Subject: Docket No. 50-482: Relocation of Technical Specification Cycle Specific Parameters to the Core Operating Limits Report

Wolf Creek Nuclear Operating Corporation (WCNOC) herewith transmits an application for amendment to Facility Operating License No. NPF-42 for the Wolf Creek Generating Station (WCGS).

ATTACHMENT III
MARKUP OF TECHNICAL SPECIFICATION PAGES

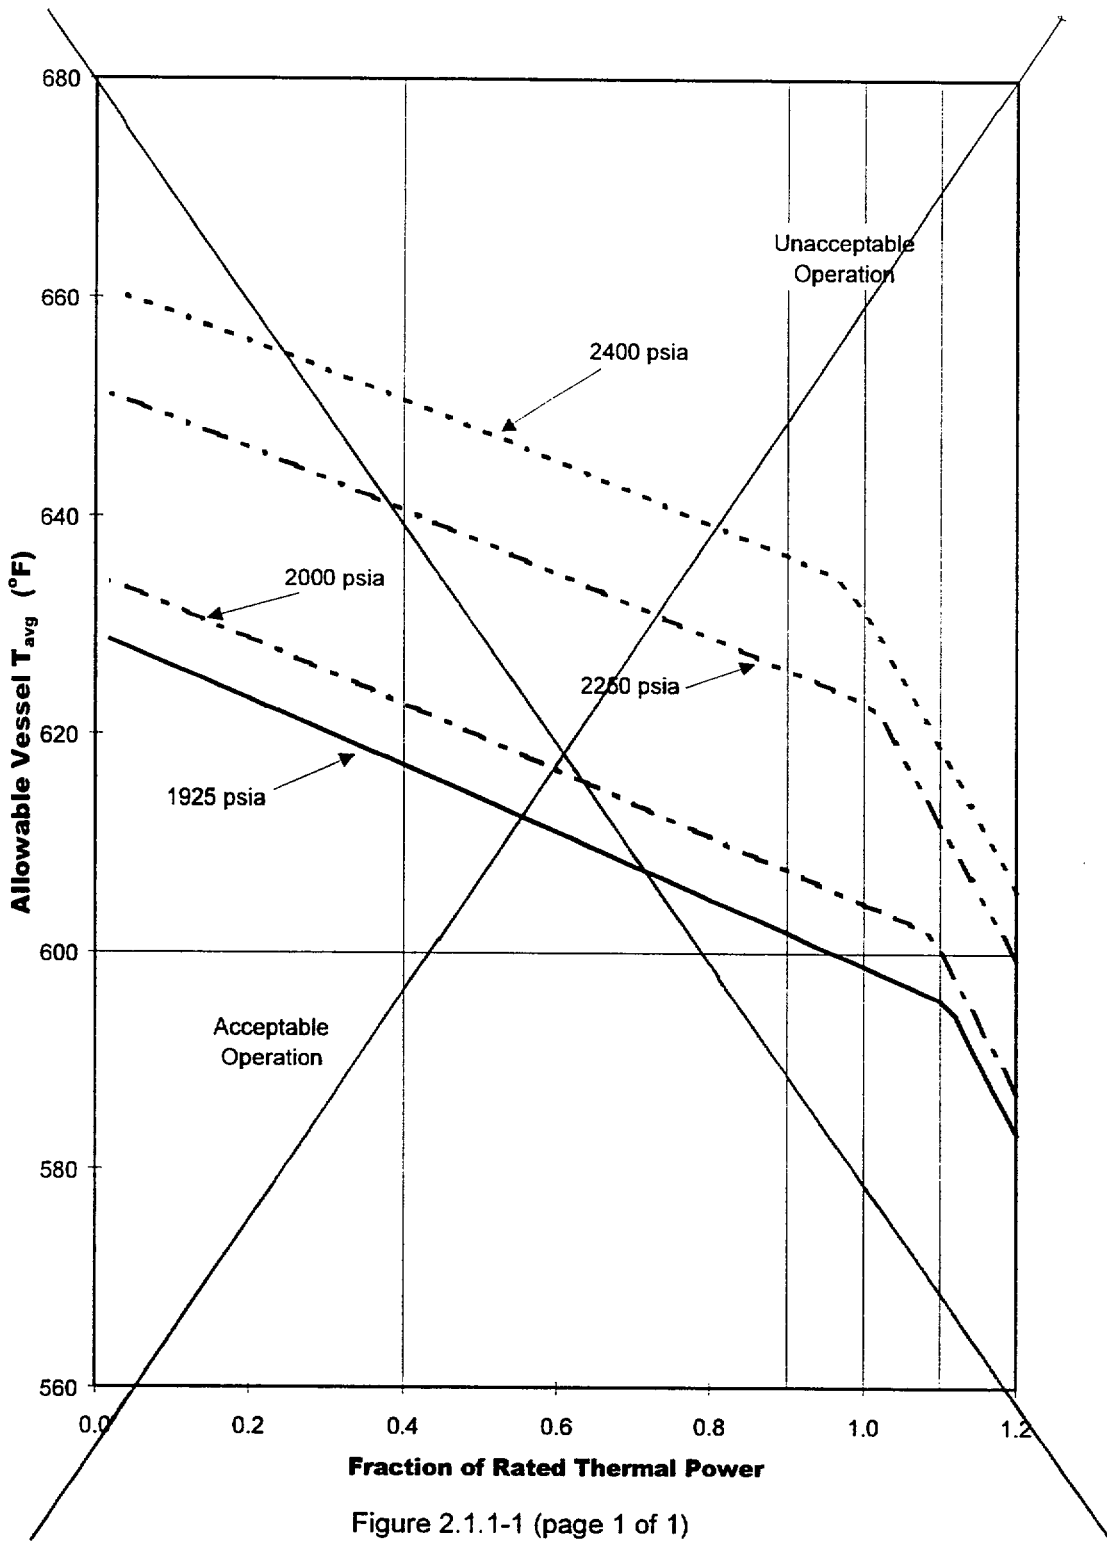
TS Figure 2.1.1-1, "Reactor Core Safety Limits," is being relocated to the COLR, and is being replaced with more specific fuel departure from nucleate boiling ratio (DNBR) and peak fuel centerline temperature safety limits.

the COR; and the following SLs shall not be exceeded:

2.1.1.1 The departure from nucleate boiling ratio (DNBR) shall be maintained ≥ 1.23 for the WRB-2 DNB correlation, and ≥ 1.30 for the W-3 DNB correlation.

2.1.1.2 The peak fuel centerline temperature shall be maintained $\leq 5080^{\circ}\text{F}$, decreasing by 58°F per 10,000 MWD/MTU of burnup.

Table 3.3.1-1 (page 5 of 6)
Reactor Trip System Instrumentation

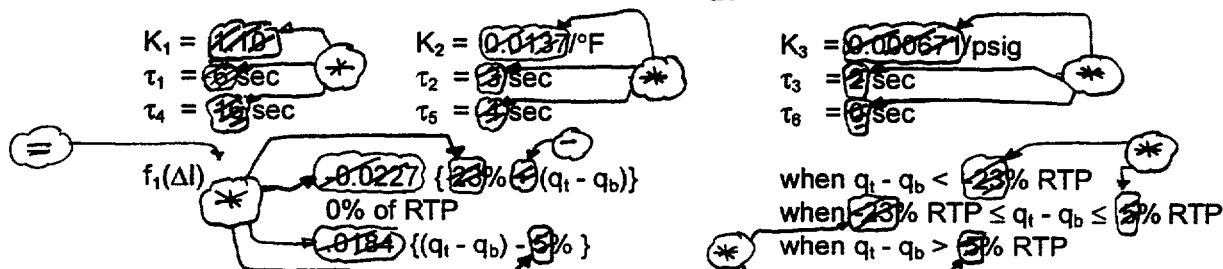
T' is the nominal T_{avg} at RTP, $\leq 566.8^\circ\text{F}$.

P' is the nominal RCS operating pressure ≥ 2225 psig.

The values denoted with * are specified in the COLR.

Table 3.3.1-1 (page 6 of 6)
Reactor Trip System Instrumentation

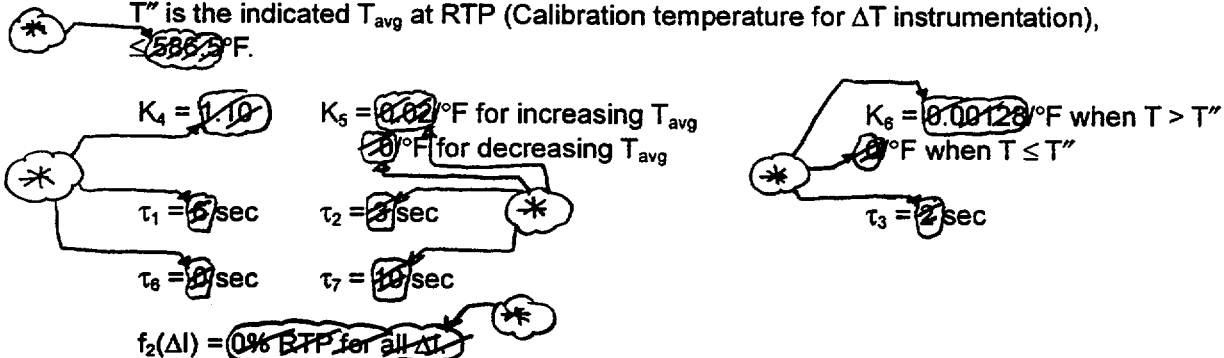
T'' is the indicated T_{avg} at RTP (Calibration temperature for ΔT instrumentation),

The values denoted with * are specified in the COLR.
